RESPONSE TO REQUEST FOR ADDITIONAL INFORMATION

APR1400 Design Certification

Docket No. 52-046

RAI No.: 233-8244
SRP Section: 05.02.02 - Overpressure Protection
Application Section: 5.2.2, 5.4.10 and 6.4.14
Date of RAI Issue: 10/02/2015

Figure 2.4.1-2 Reactor Coolant System (Pressurizer)

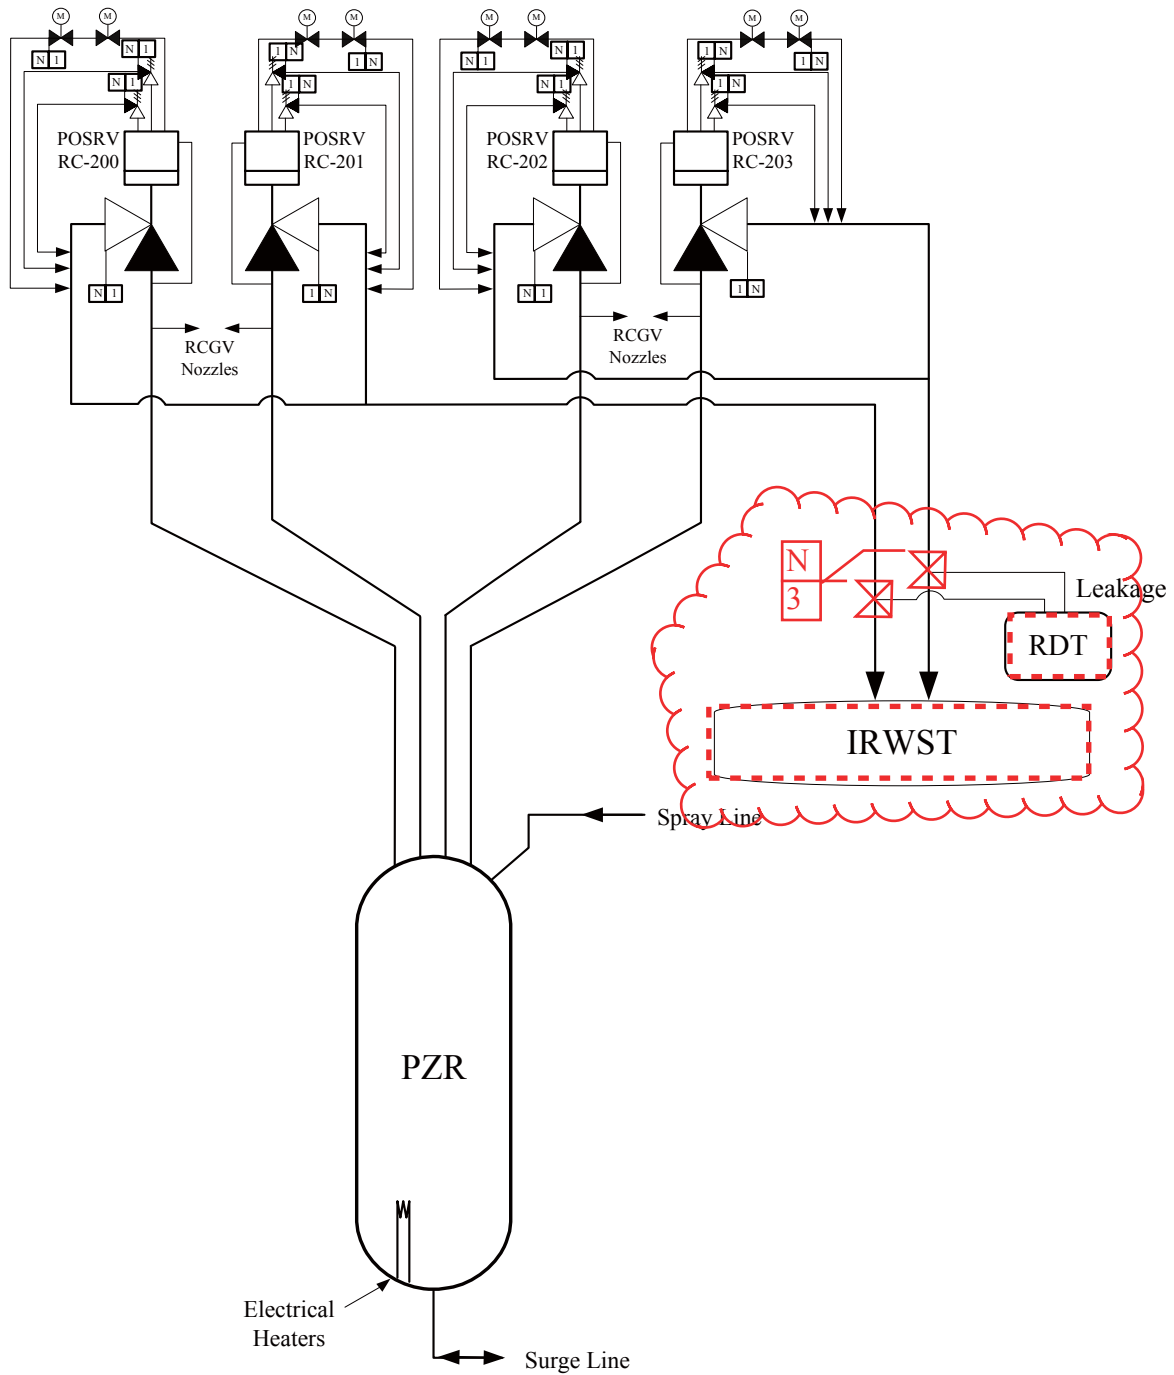
- b. DCD Section 5.2.2.3, "Flow Diagrams," provides the reference to flow diagrams for the overpressure components and states, "The flow diagram showing the in-containment refueling water storage tank (IRWST) is given in Figure 6.8-3." DCD Tier 1, Figure 2.4.2-1 shows the discharge of the POSRV into the IRWST. Figure 6.8-3, "Incontainment Water Storage System Flow Diagram," shows the piping connections for the SCS relief valve discharge, but the staff is unable to locate the POSRV discharge connections to the IWRST. The applicant is requested to verify the location of

the POSRV discharge connection to IRWST in Figure 6.8-3. In addition, an inconsistency may exist between Tier 1 and 2 regarding this piping configuration. The applicant should verify the proper configuration and update DCD for consistency

DCD Tier 1 Table 2.4.1-1, Table 2.4.1-2, and Figure 2.4.2-1 will be revised to clarify the classification of the POSRV discharge piping and to be consistent between the DCDs.

- b. The location of the POSRV discharge connection to the IRWST is shown on Figure 2.4.1-2 in Tier 1 and Figure 5.1.2-3 in Tier 2, but not Figure 6.8-3, each of which is the schematic and flow diagram for Pressurizer and POSRV including the portion of the POSRV discharge, respectively. Therefore consistency exists between Tier 1 and Tier 2. On the other hand, Figure 6.8-3 shows the flow diagram of the in-containment water storage system (IW) and the IW system does not include the portion of the POSRV discharge.

DCD Tier 1 Table 2.4.1-1, Table 2.4.1-2, and Figure 2.4.2-1 will be revised, as shown in the attachment associated with this response.
